SERVICE BULLETIN

#0020 Revision 2

SUBJECT: Eyebolt inspection and conditional replacement

MODELS AFFECTED: All Sling aircraft manufactured before the effective date (07/09/2022)

Figure 14: Aileron leading edge eyebolt assembly

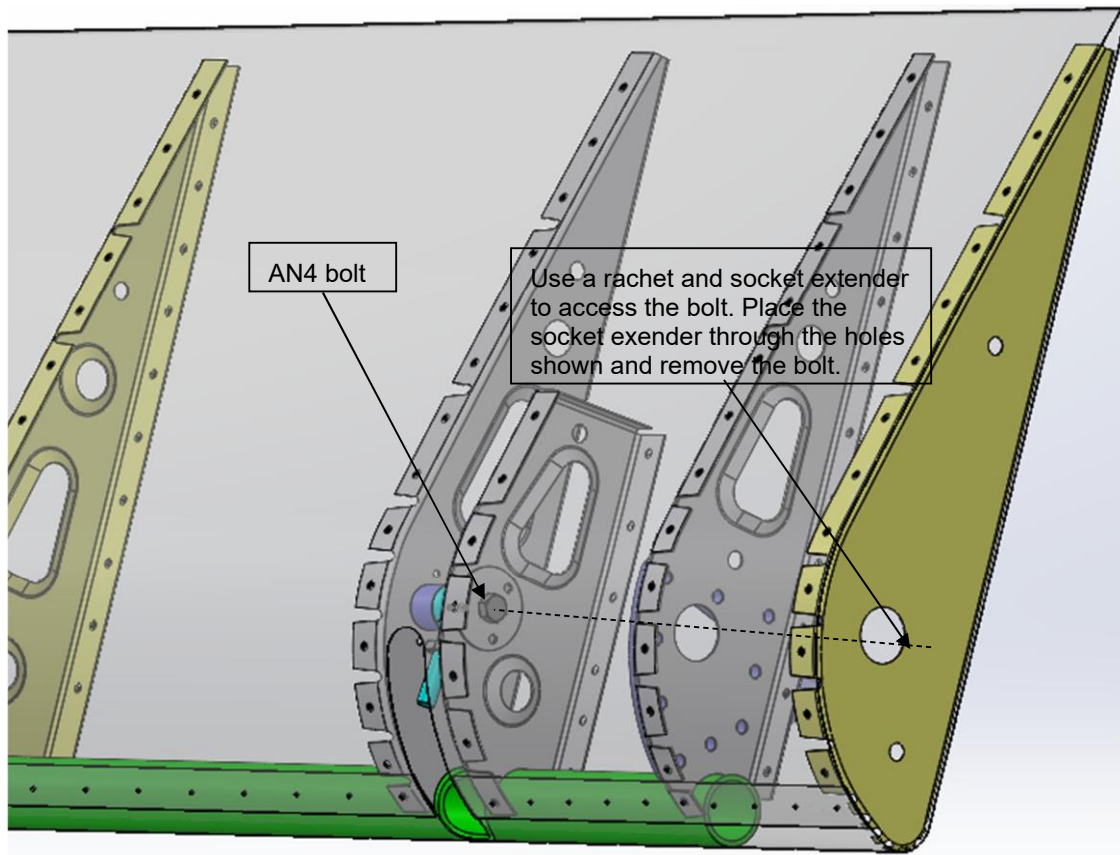
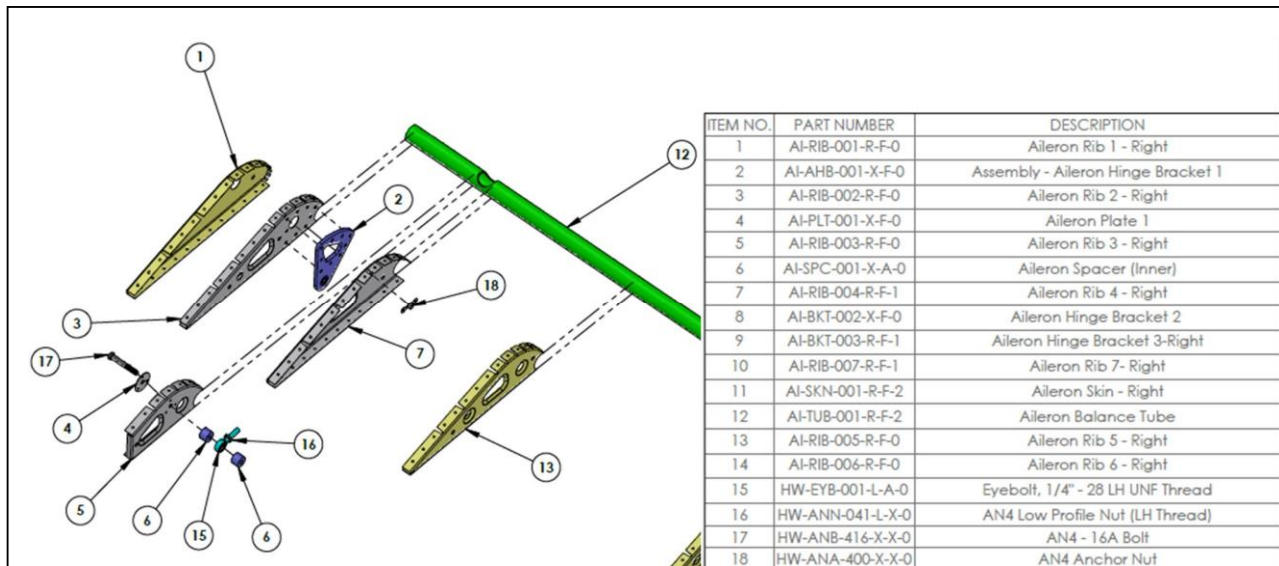
Step 11. For the eyebolts located at the ailerons leading edge, remove the AN4 bolt (9) shown in Figure 14. To access this bolt, you will need to drop the flap. To do this follow steps 1 and 2 *only*, of the Flap removal procedure (Option1). This procedure can be found in Section 4.1.3.2 of manual DC-MAM-001-X-F. Remember to support the aileron and flap during this step as they may drop.

Step 12. After the bolt has been removed, the eyebolt can be replaced with either a *type 1* or *type 2* eyebolt. It should then be reconnected to the aileron and pushrod, as shown in Figure 15.

Figure 16: Flap Controls

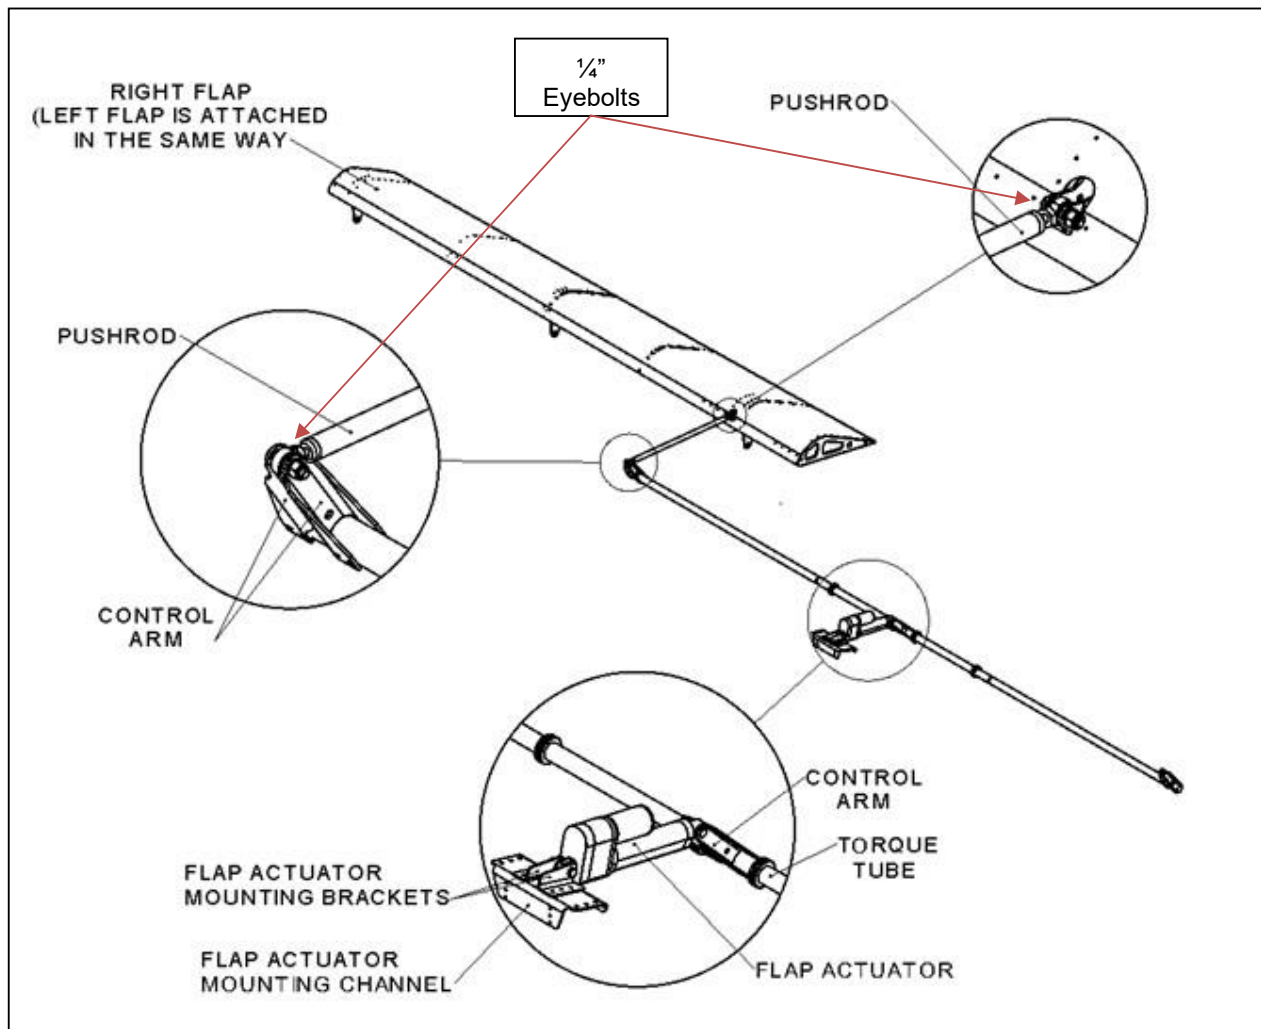
The eyebolts used in the flap control assembly can be seen in Figure 16. These can be inspected using the inspection hatches located on the wing. Due to symmetry only one flap has been shown. The same eyebolts will be found on the other side of the aircraft. The eyebolts need to be inspected and replaced where *noncompliant* eyebolts have been installed.

Step 2. The eyebolt can then be replaced with a *type 1* or *type 2* eyebolt if required.

Step 5. The eyebolt can then be replaced with a *type 1* or *type 2* eyebolt if required.

Figure 17: Sling 2 and Sling LSA elevator control system

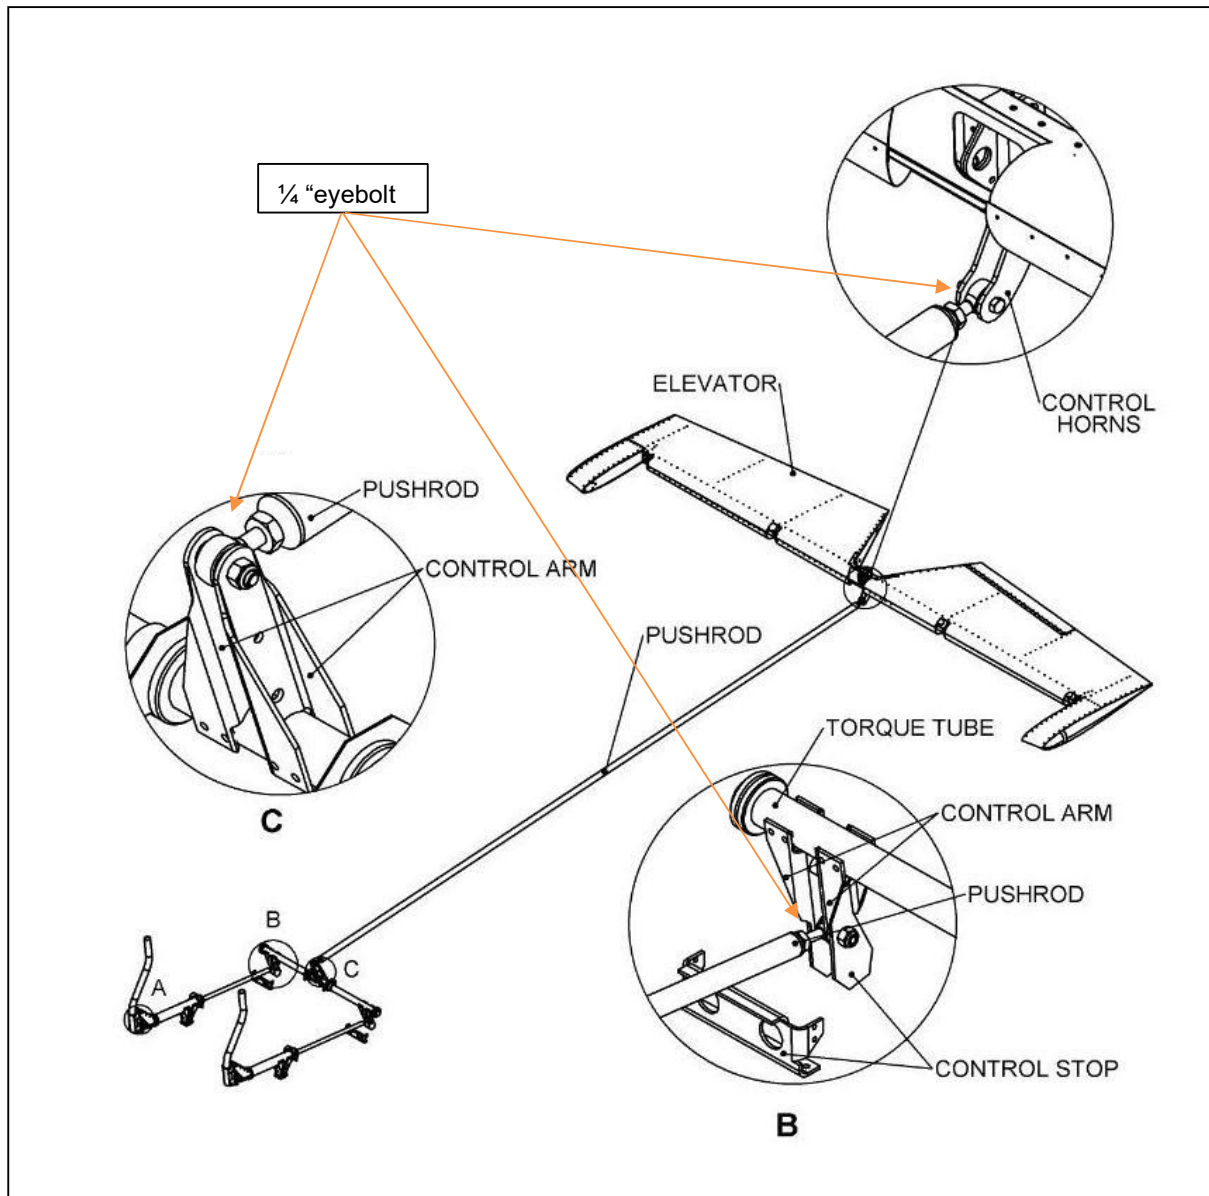
This section is only applicable to the Sling 2 and Sling LSA. The eyebolts used in the Sling 2 and Sling LSA elevator controls can be seen in Figure 17.

Figure 18: Eyebolt assembly, Detail C

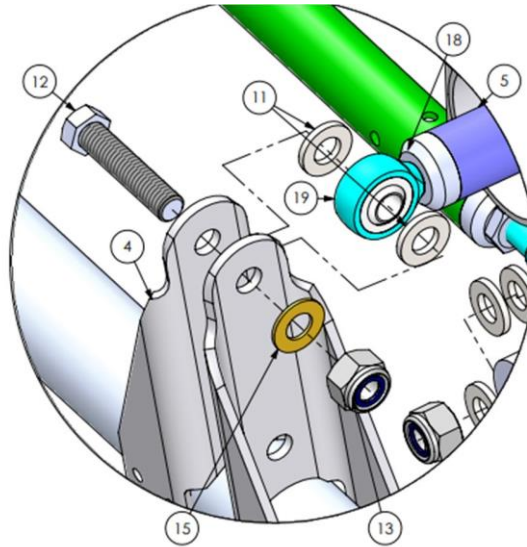
- Step 3. Refer to Figure 18. If a *noncompliant* eyebolt has been used, it must be replaced (with either a *type 1* or *type 2*). To do this, remove the AN4 locknut (13) and bolt (12). The eyebolt can now be uninstalled from the pushrod and a new one can be installed.
- Step 4. Once the new eyebolt has been installed onto the pushrod, reconnect the eyebolt assembly. Refer to Figure 18 for part layout.
- Step 5. Next, the eyebolts seen in Detail B of Figure 17 will need to be inspected and replaced if found to be *noncompliant*.
- Step 6. An enlarged view of Detail B can be seen in Figure 19.

Figure 19: Enlarged view of eyebolt assembly of Detail B

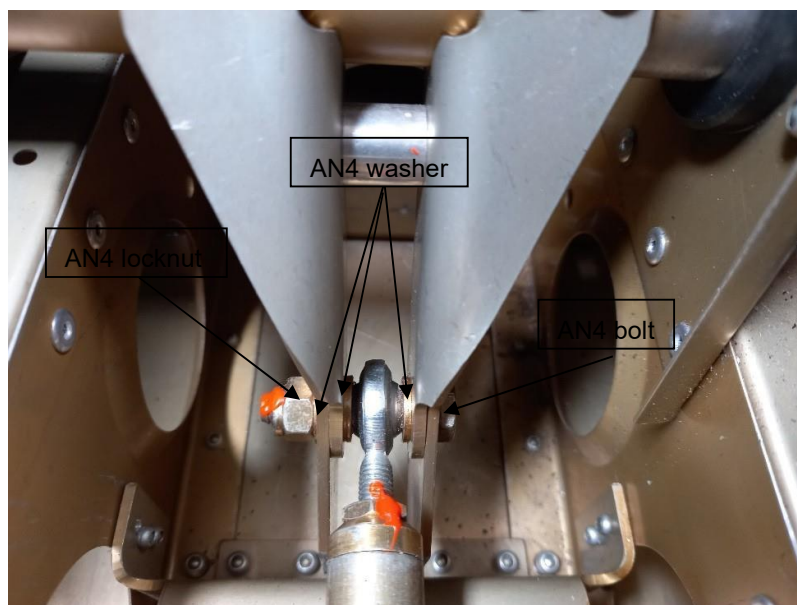
- Step 7. Refer to Figure 19 and remove the locknut and bolt.
- Step 8. Replace the *noncompliant* eyebolt with a *type 1* or *type 2*.
- Step 9. Reinstall the components, as shown in Figure 19.
- Step 10. Repeat Step 7 to Step 9 for the corresponding eyebolt assembly on the other side of the aircraft.

Figure 20

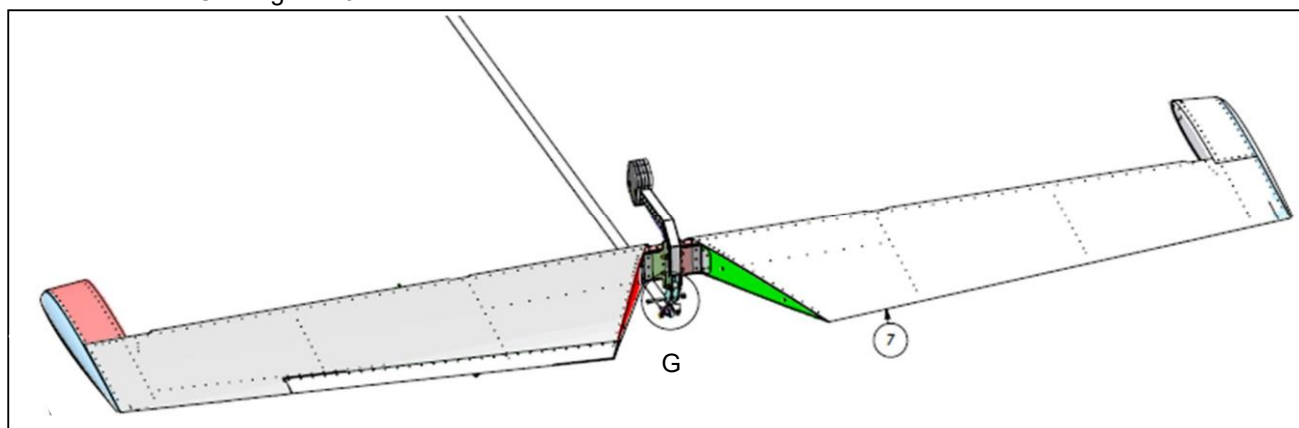
Step 11. The last eyebolt that needs to be inspected and replaced is the one connected to the elevator horn in detail G of Figure 20.

Figure 22: Detail G

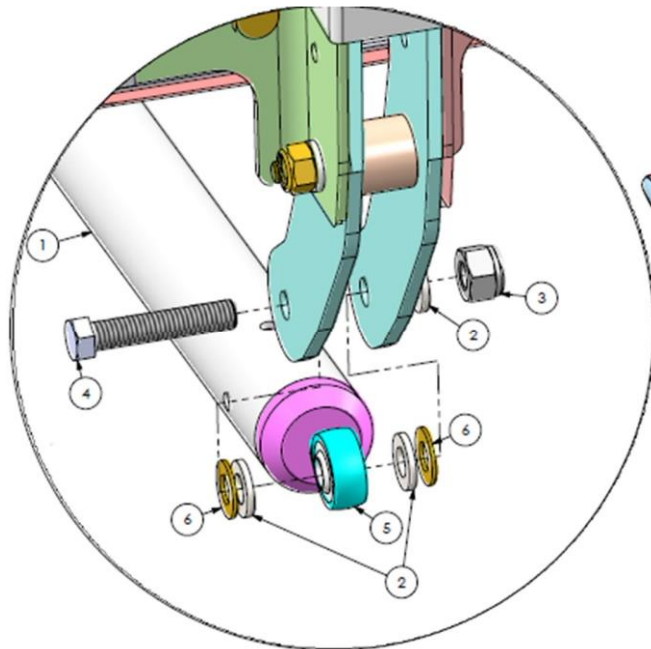
Step 13. Remove the AN4 locknut (3) and bolt (4), shown in Figure 22.

- Step 14. Replace the *noncompliant* eyebolt (5) with either a *type 1* or *type 2*.
 Step 15. Reassemble the eyebolt assembly as seen in Figure 22.
 Step 16. You will need to adjust the elevator once the new eyebolts are installed to ensure correct elevator deflection. To do this follow the instructions in the applicable MAM shown in the table below:

Figure 23

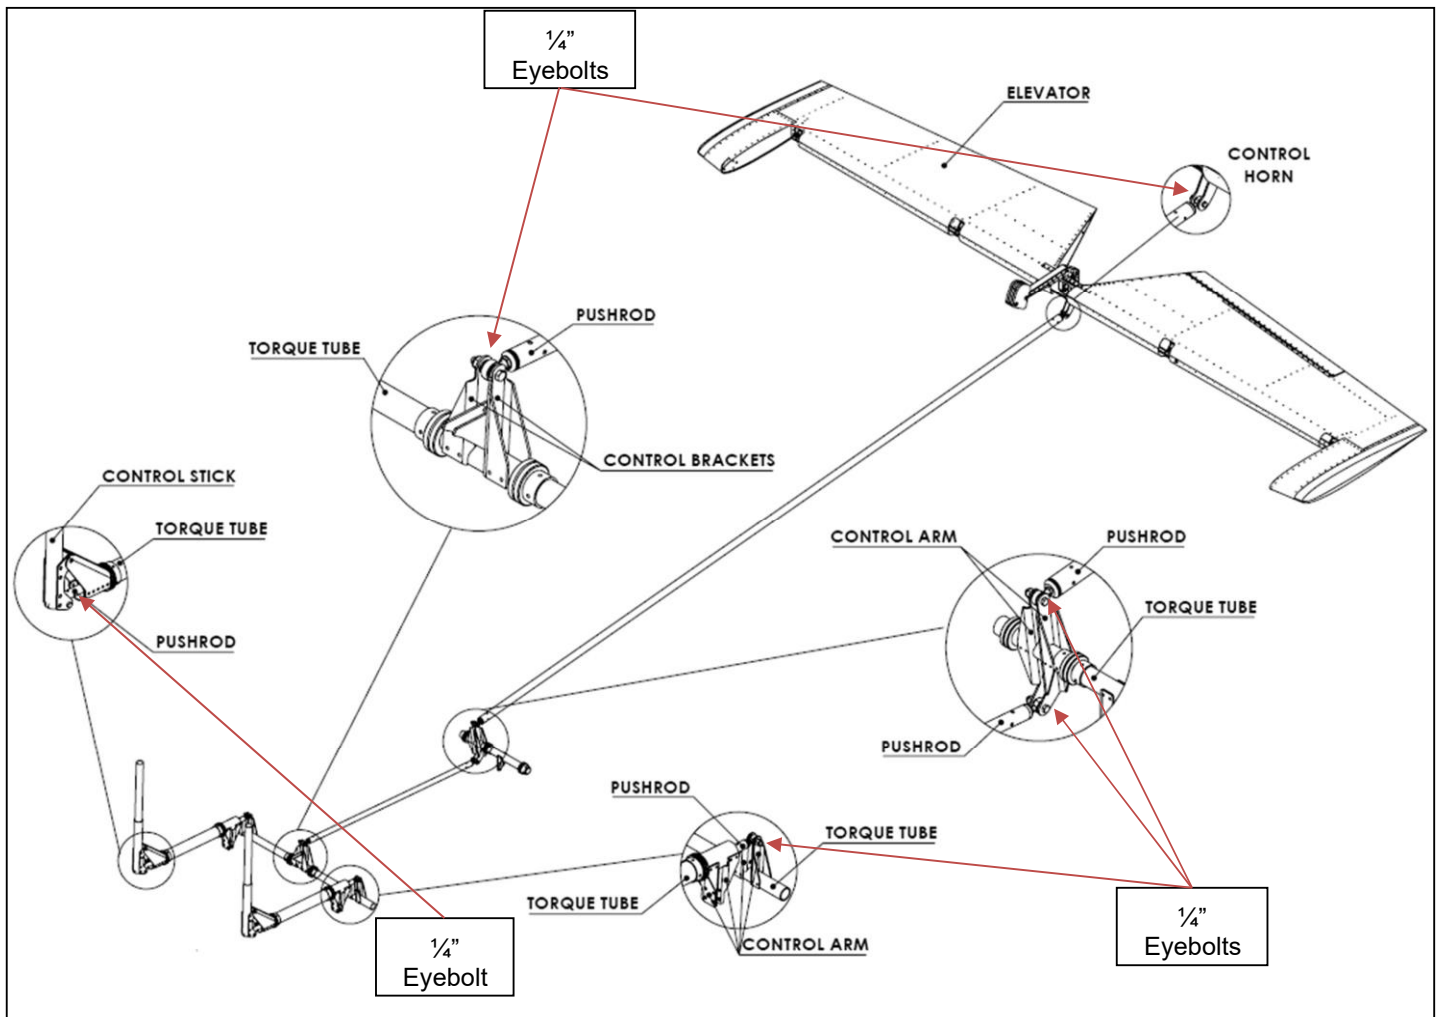
This section is only applicable to the Sling 4 and Sling 4 TSi. The eyebolts used in the elevator controls can be seen in Figure 23. The eyebolts need to be inspected and replaced where *noncompliant* eyebolts have been installed.

Figure 24: Eyebolt assembly, Detail A

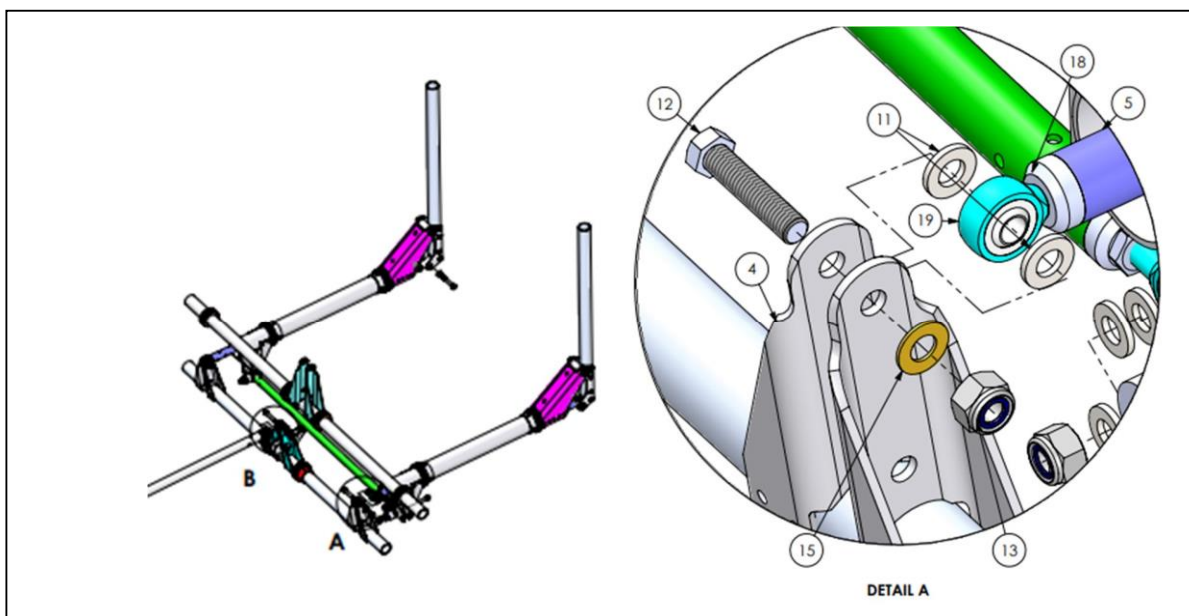
- Step 3. If *noncompliant* eyebolts have been used, they must be replaced (with either *type 1* or *type 2*). To do this remove the AN4 locknut (13) and bolt (12), as seen in Figure 24. The eyebolt can now be uninstalled from the pushrod. Once uninstalled, install a new one of either *type 1* or *type 2*.
- Step 4. Once the eyebolt has been installed onto the pushrod, reconnect the eyebolt assembly. Refer to Figure 24 for the way the assembly fits together.
- Step 5. Next inspect the eyebolts seen in Detail B of Figure 25.

Figure 25: Eyebolt assembly, Detail B

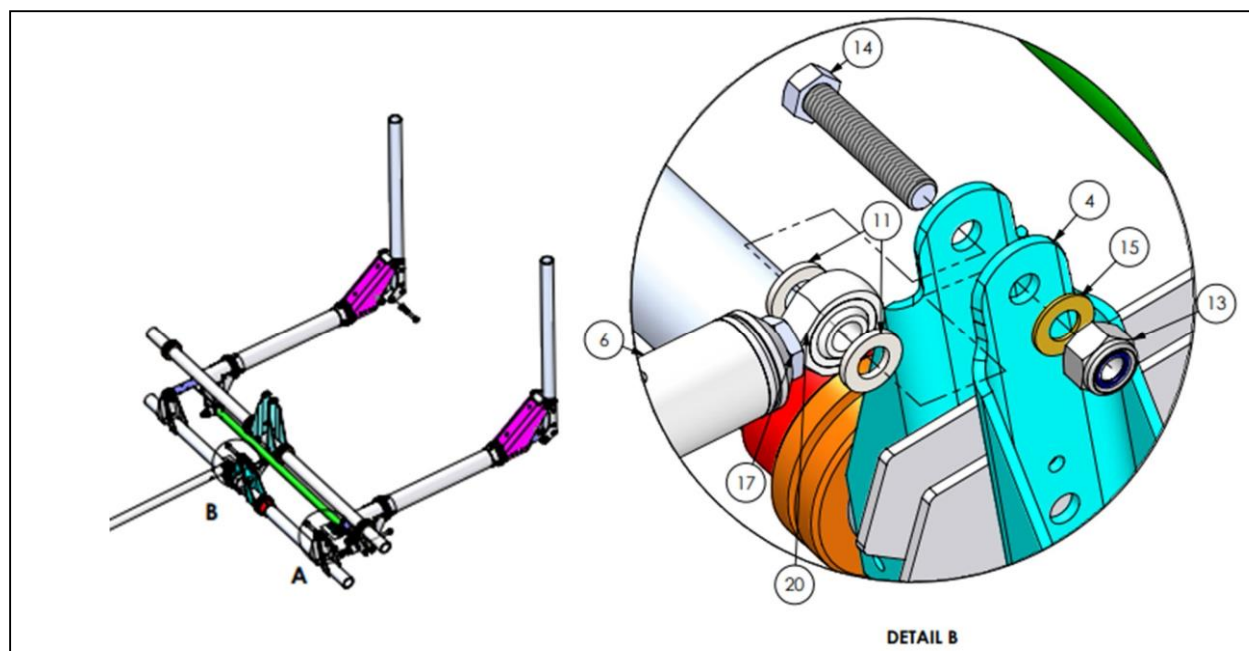
- Step 6. Remove the AN4 locknut (13) and bolt (14), as seen in Figure 25. Once removed the eyebolt can be uninstalled and an eyebolt of *type 1* or *type 2* can be reinstalled.
- Step 7. Reassemble the eyebolt assembly, refer to Figure 25 for part placement.

Figure 26

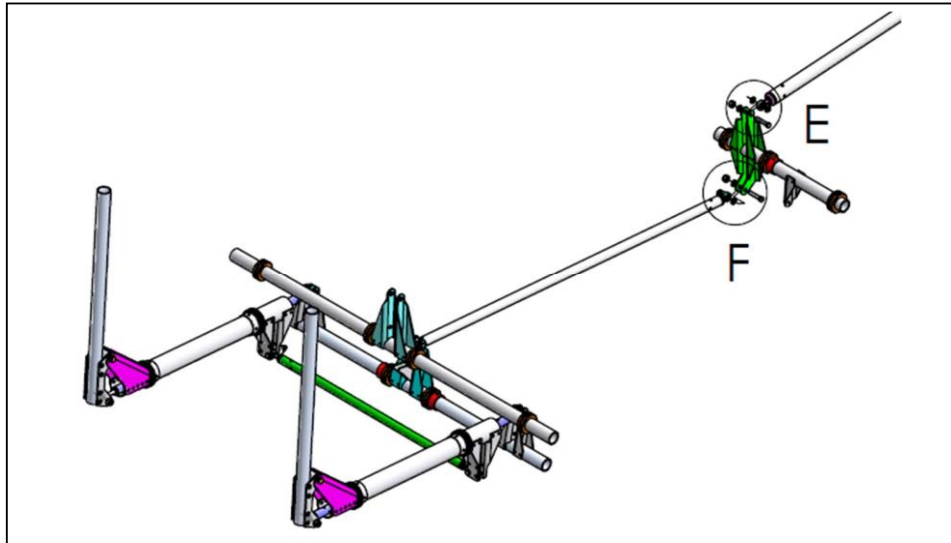
- Step 8. Next, the eyebolts seen in Detail E and F in Figure 26 will need to be inspected and replaced if found to be of *noncompliant*. To access these in the Sling 4 TSi, remove the rear seats. To do this follow the instructions in the applicable MAM shown in the table below:

Figure 27: Eyebolt assembly, Detail E

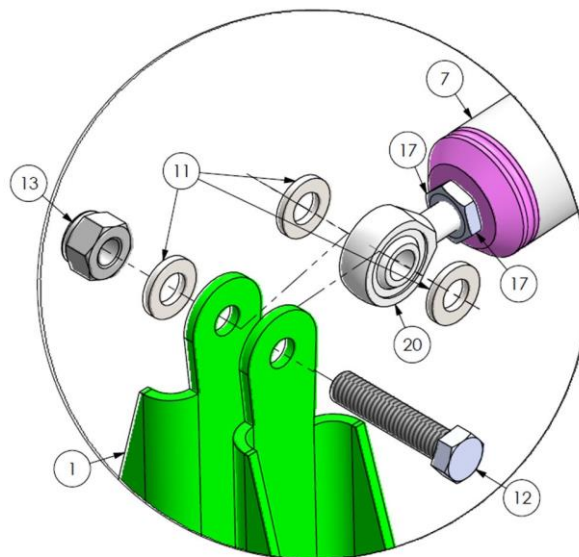
- Step 9. To replace the eyebolt seen in Figure 27, remove the AN4 locknut (13) and bolt (12). Replace the *noncompliant* eyebolt (20) with either a *type 1* or *type 2* eyebolt.

- Step 10. Once the eyebolt has been replaced, reassemble the eyebolt assembly. Refer to Figure 27 for component positions.
- Step 11. To replace the eyebolt seen in Figure 28, remove the AN4 locknut (13) and bolt (12). Replace the *noncompliant* eyebolt with either a *type 1* or *type 2* eyebolt.
